FirstEnergy Nuclear Operating Company

Beaver Valley Power Station, Unit No. 1  
Docket No. 50-334, License No. DPR-66  
Completion of Required Action by NRC Order EA-12-051, Reliable Spent Fuel Pool Instrumentation (TAC No. MF0799)

NRC Requests for Information  
Page 1 of 39

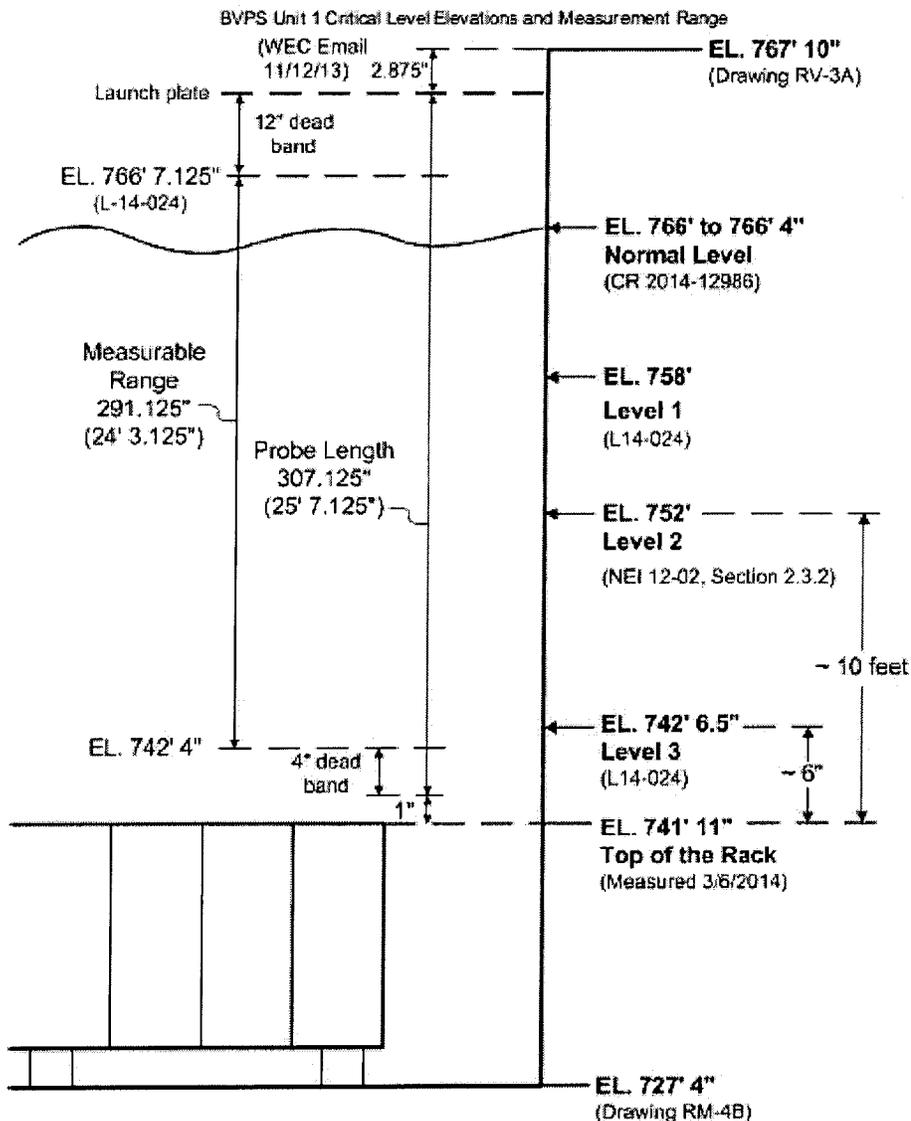
**Please provide a clearly labeled sketch depicting the elevation view of the proposed typical mounting arrangement for the portions of the instrument channel consisting of permanent measurement channel equipment (e.g., fixed level sensors and/or stilling wells, and mounting brackets). Indicate on this sketch the datum values representing Level 1, Level 2, and Level 3, as well as the top of the fuel racks. Indicate on this sketch the portion of the level sensor measurement range that is sensitive to measurement of the fuel pool level, with respect to the Level 1, Level 2, and Level 3, datum points.**

By letter dated February 27, 2014, FENOC provided a sketch depicting the requested datum values. Subsequently, more refined measurements were obtained for the top of fuel rack and bottom of measurement range. An updated sketch is provided below.

Sketches for BVPS-1 Primary SFP Instrumentation

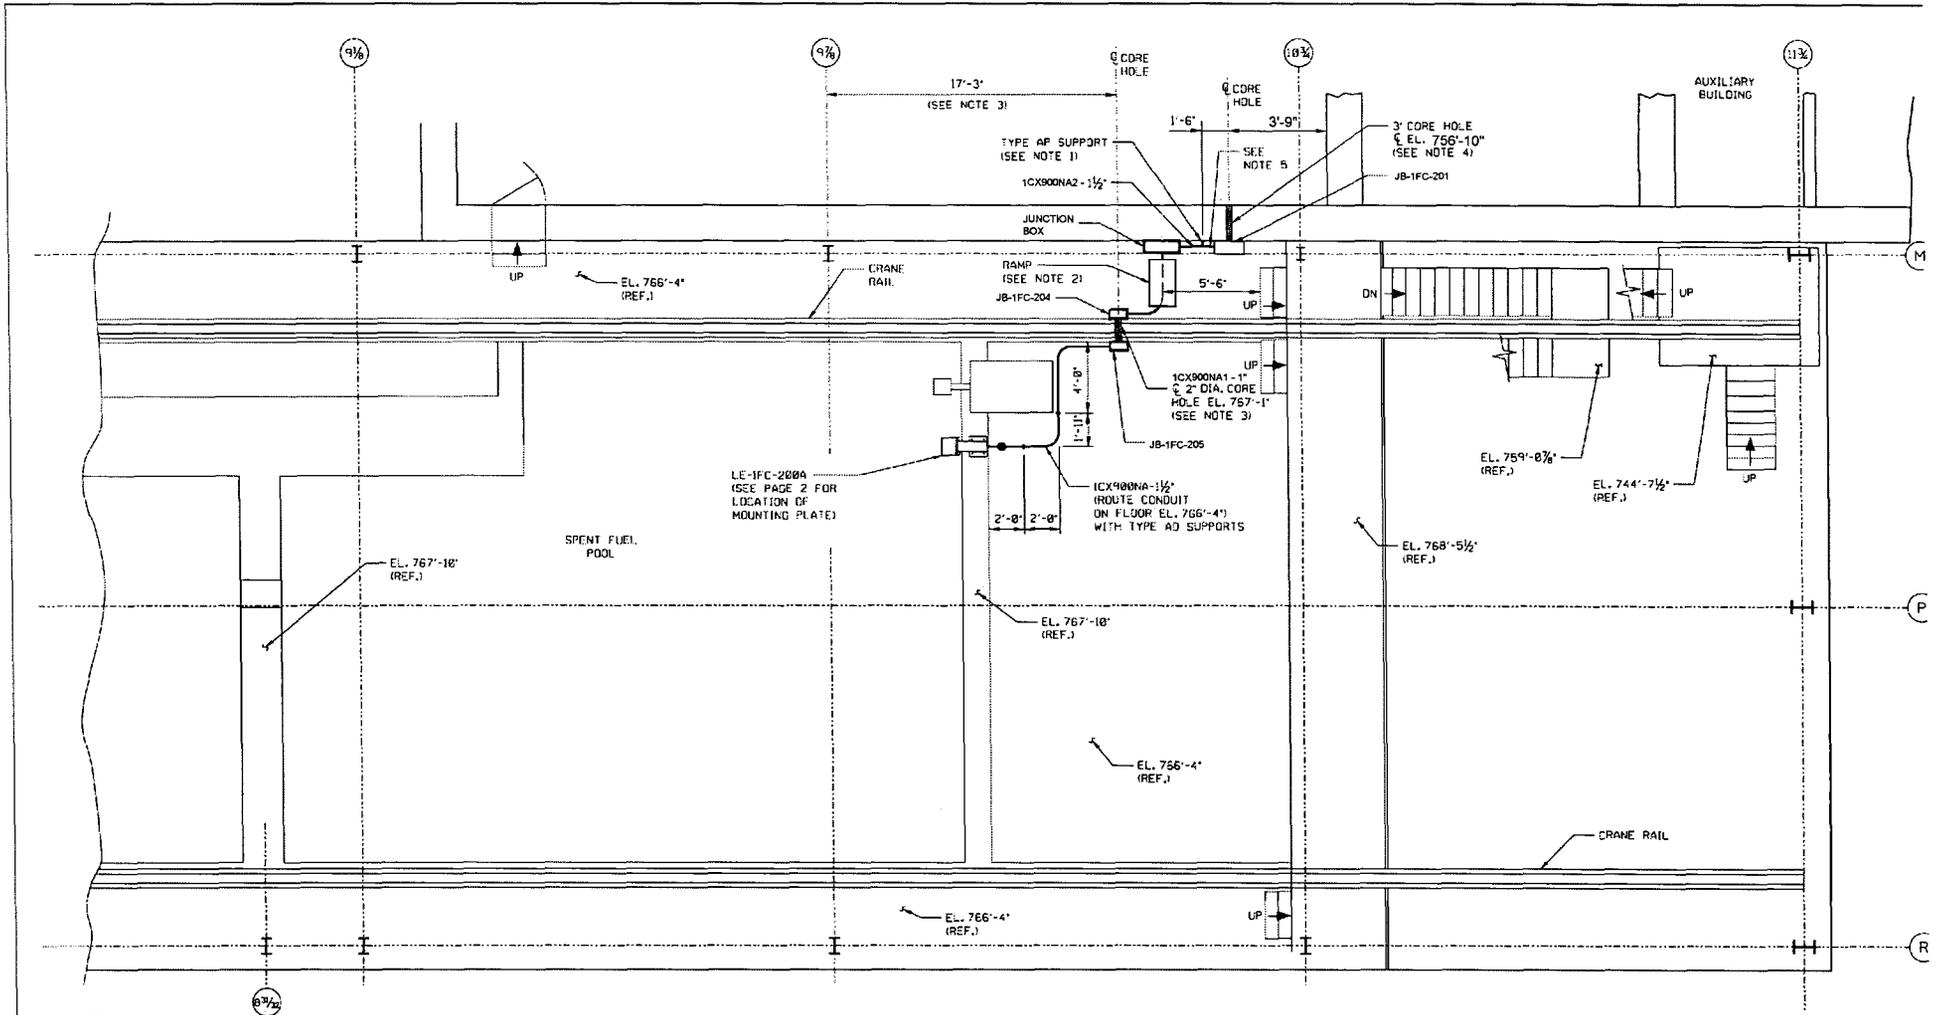
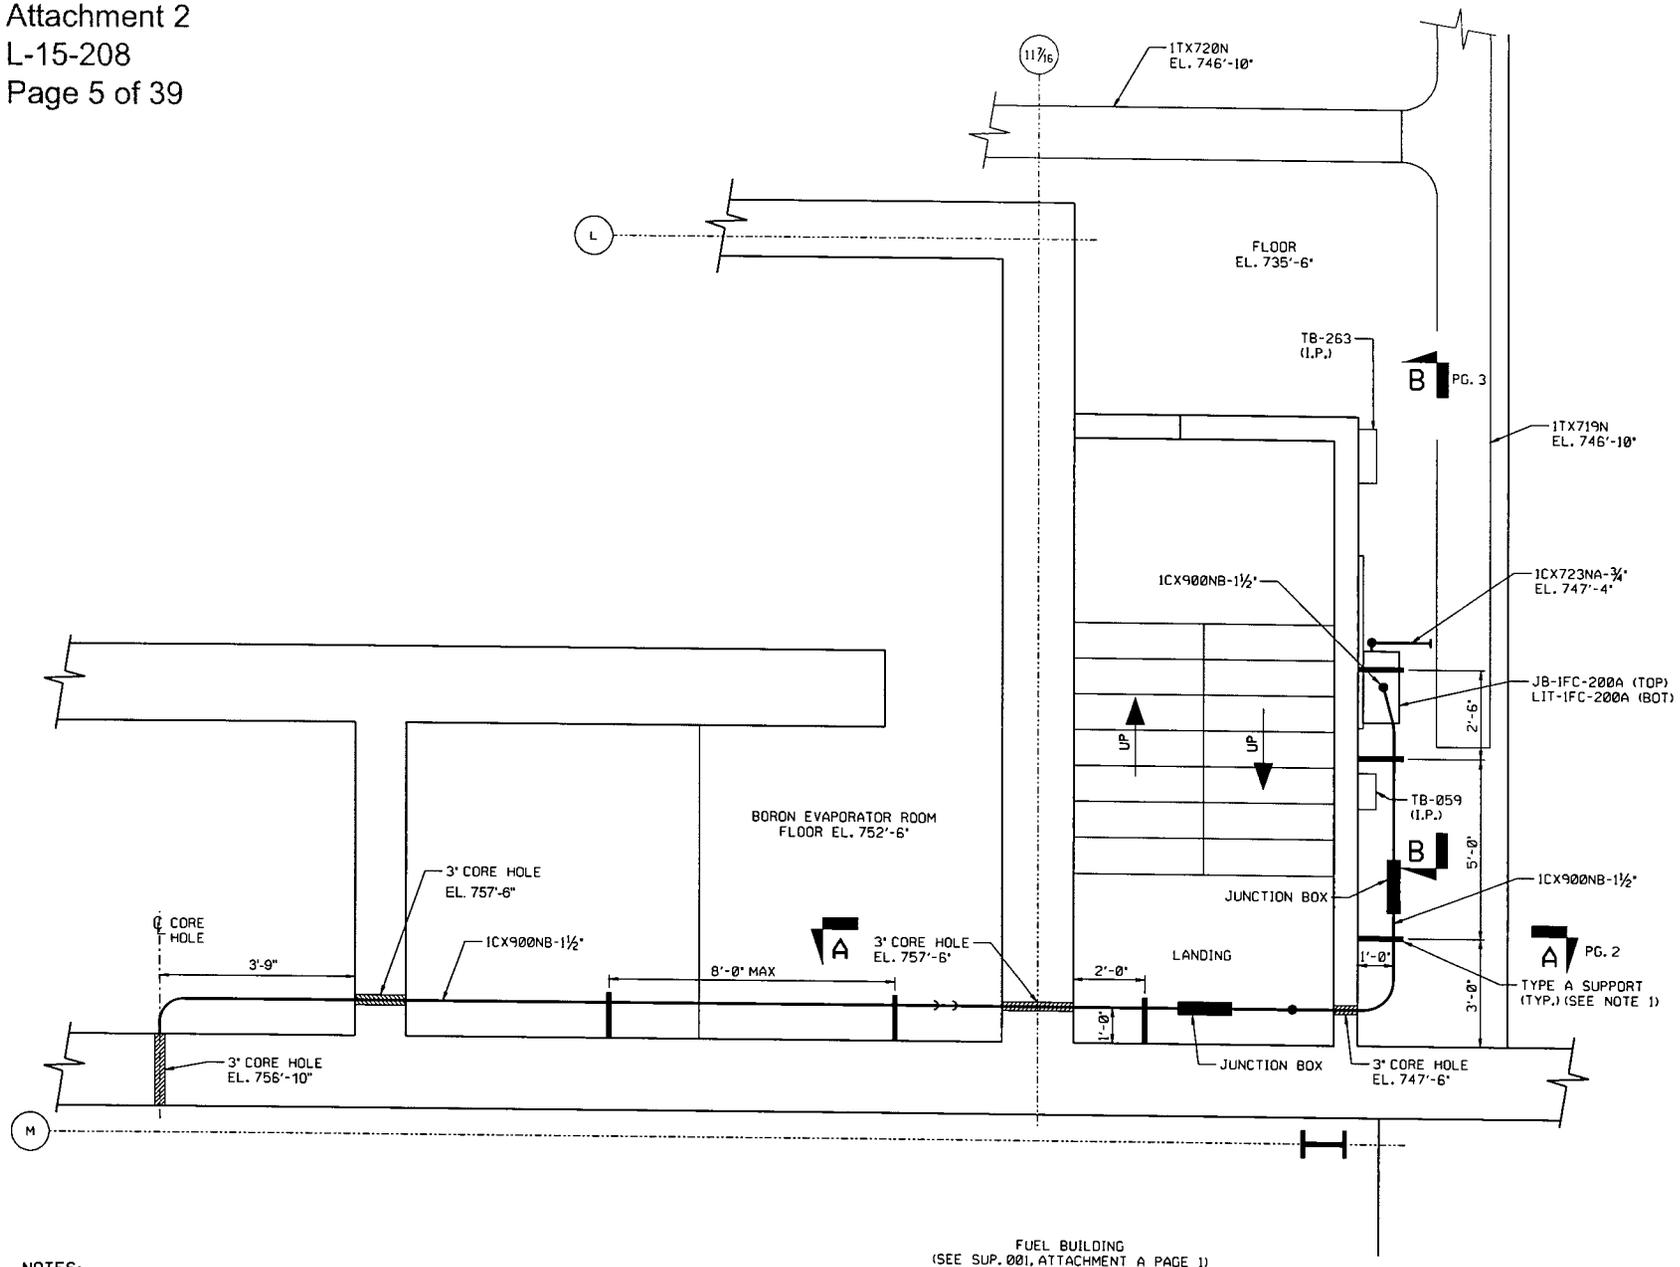
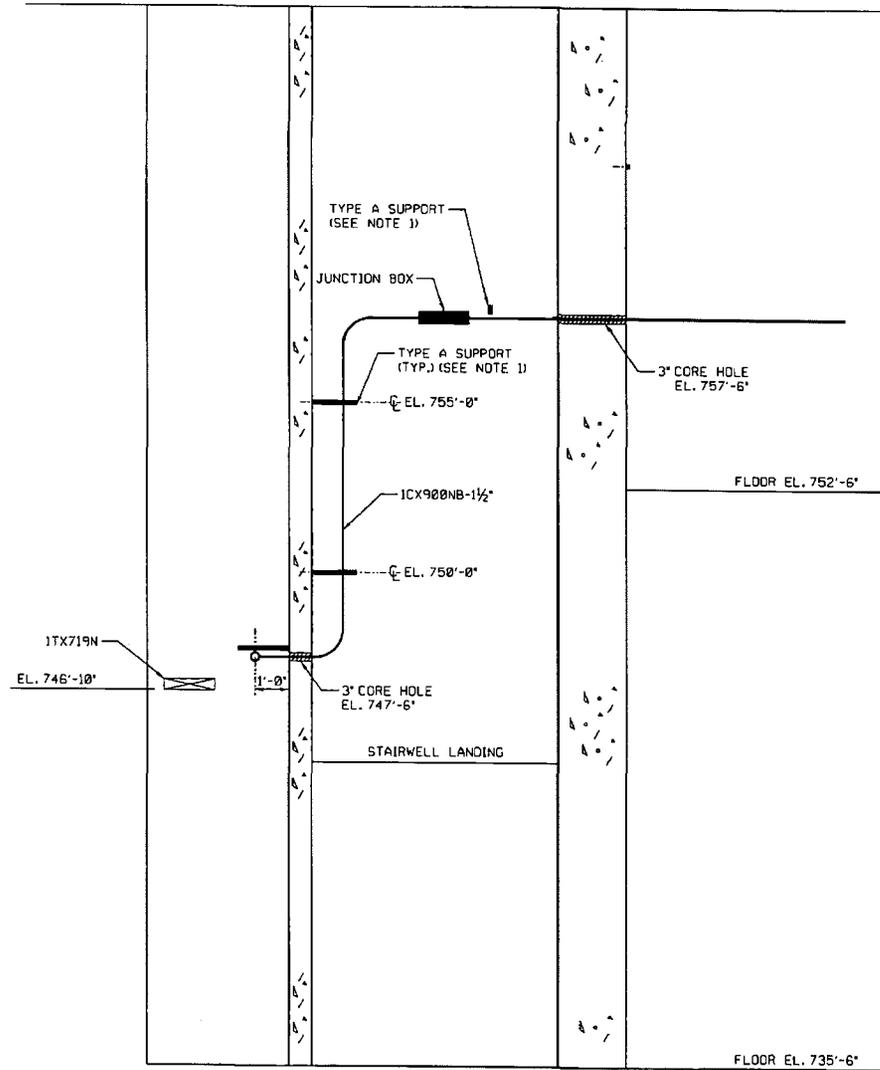
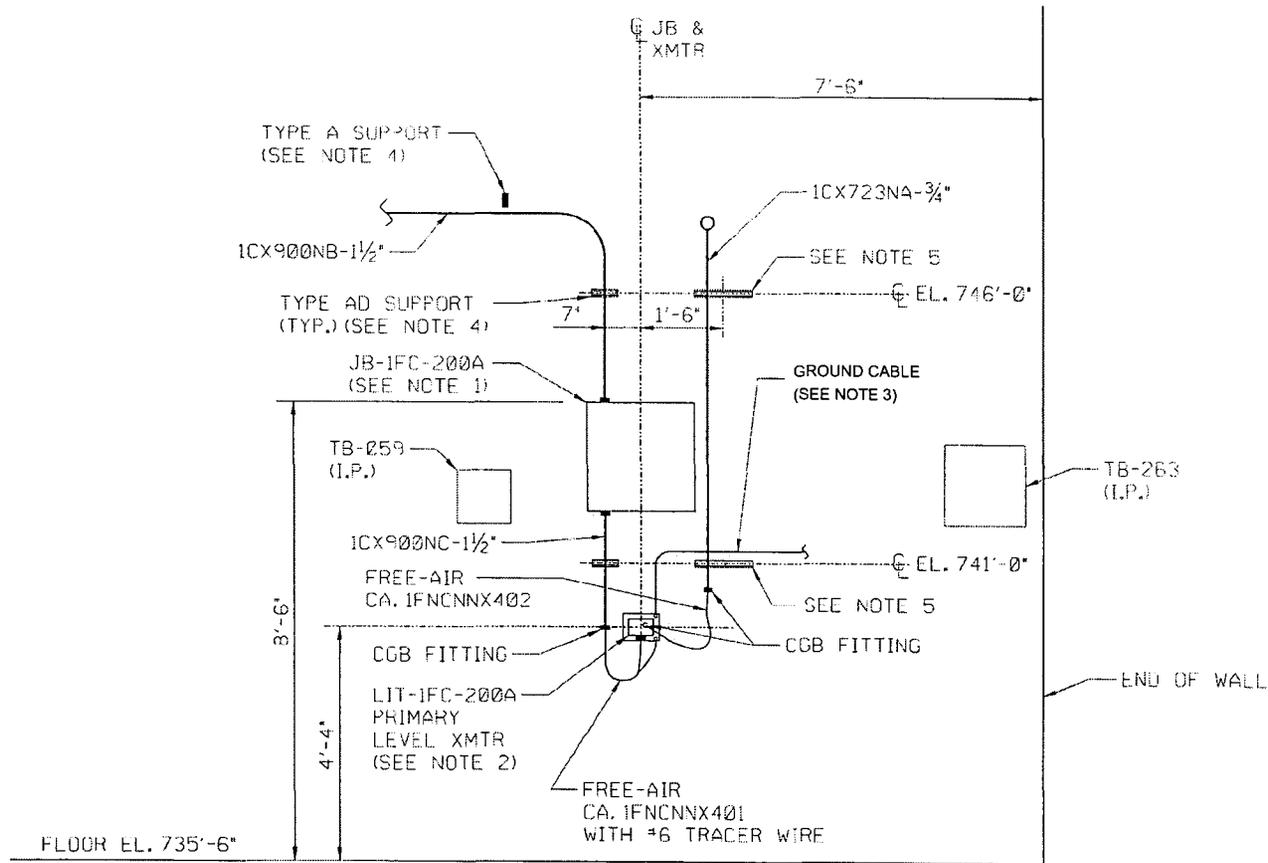
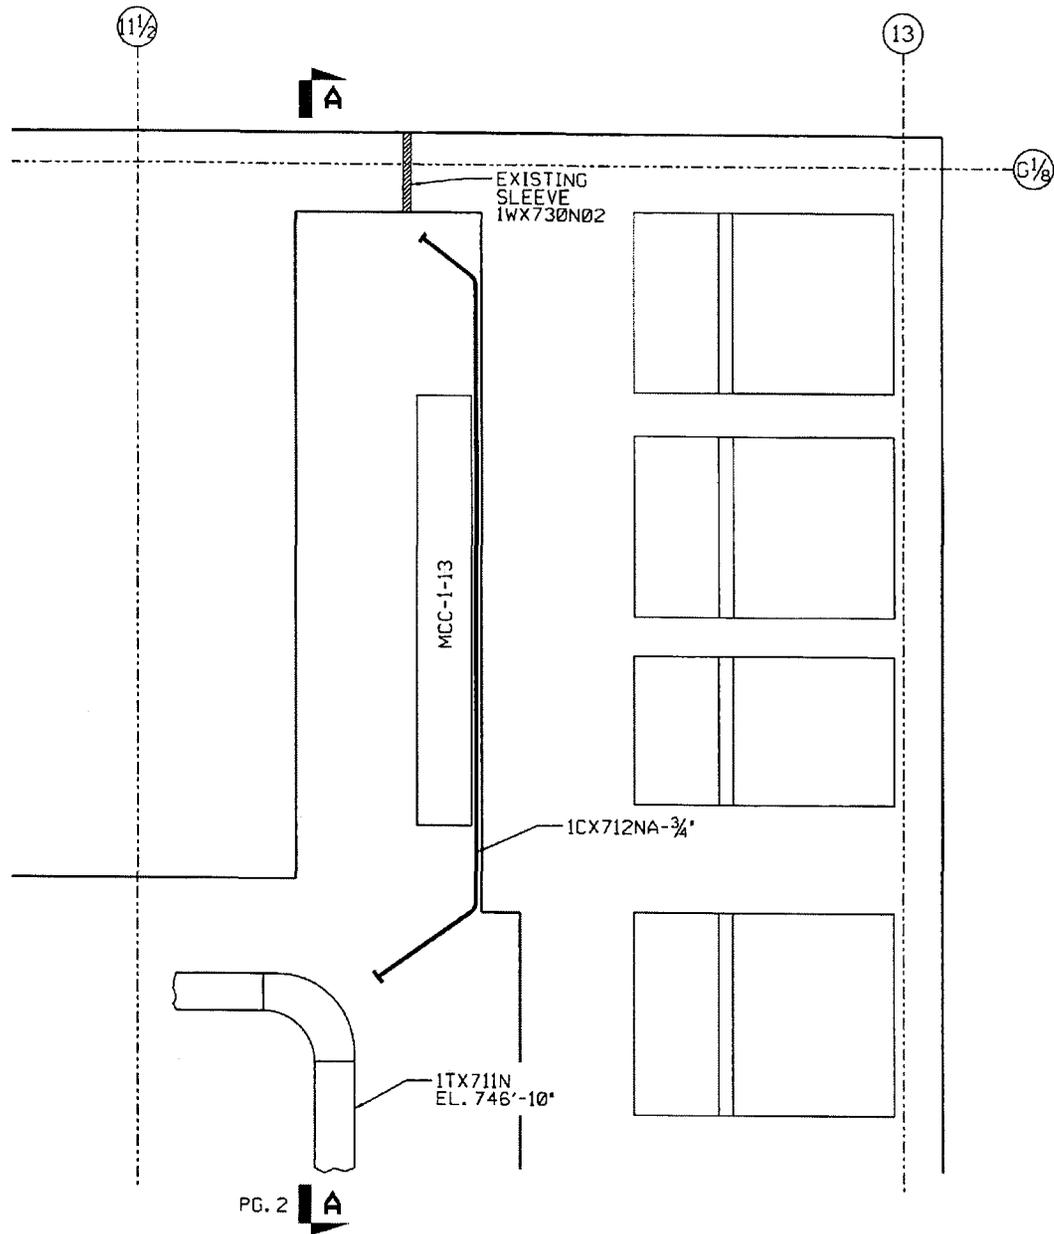
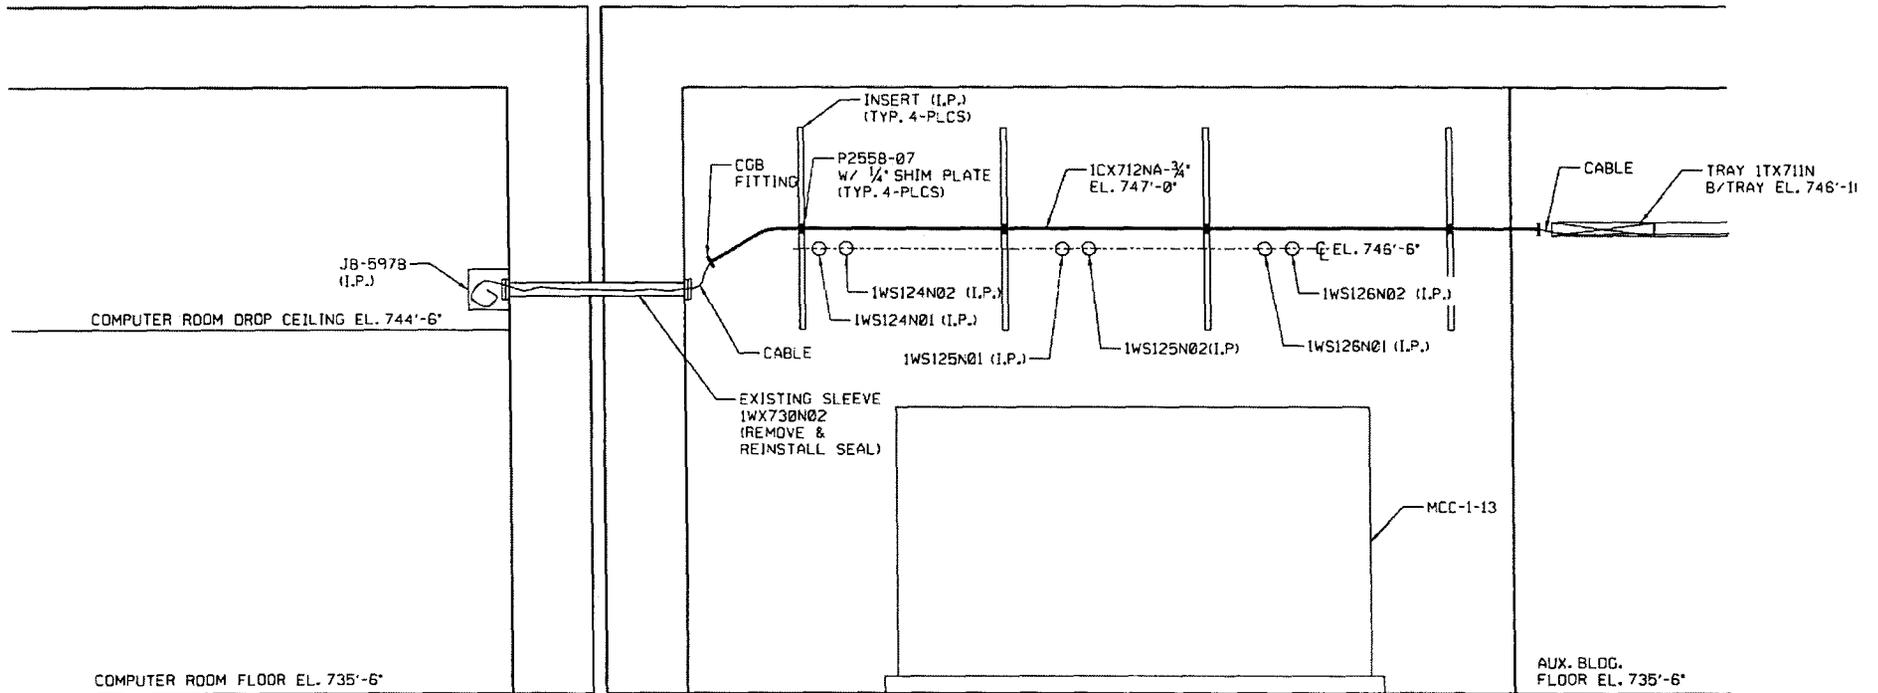
**Please provide a clearly labeled sketch or marked-up plant drawing of the plan view of the SFP [spent fuel pool] area, depicting the SFP inside dimensions, the planned locations/placement of the primary and back-up SFP level sensor, and the proposed routing of the cables that will extend from these sensors toward the location of the read-out/display device.**

The response to this RAI was provided by FENOC letter dated February 27, 2014. Subsequently, by FENOC letter dated February 26, 2015, the design for BVPS-1 progressed from conceptual design to final design. As a result, some of the locations of the instrumentation and conduit routing were changed. Updated sketches are provided below, depicting general configuration. Previous versions of these sketches were made available to the NRC staff for review.

The electronics enclosure units (transmitters) are located in an area removed from the SFP environment, which would be accessible in the event of a beyond-design-basis external event (BDBEE) that would restrict access to the SFP. The enclosures for the two instrument channels are separated to minimize the possibility of a single event damaging both channels. The primary level indicating transmitter LIT-1FC-200A is located on the west wall of the auxiliary building, general area elevation (El.) 735' 6", just east of the stairwell. The backup level indicating transmitter LIT-1FC-200B is located on the west wall of the auxiliary building, general area El. 735' 6", just east of the stairwell. The level transmitters located in the auxiliary building have a local display, although the credited display units will be located in the main control room (MCR). Cabling for each channel is run in separate conduits and cable trays to the control room indicators.

The primary electronics enclosure PNL-1FC-200A (control room analog indication) is located on the south wall of the old Shift Manager's Office in the control room, El. 735' 6". The backup electronics enclosure PNL-1FC-200B is also located on the south wall of the old Shift Manager's Office in the control room, El. 735' 6".
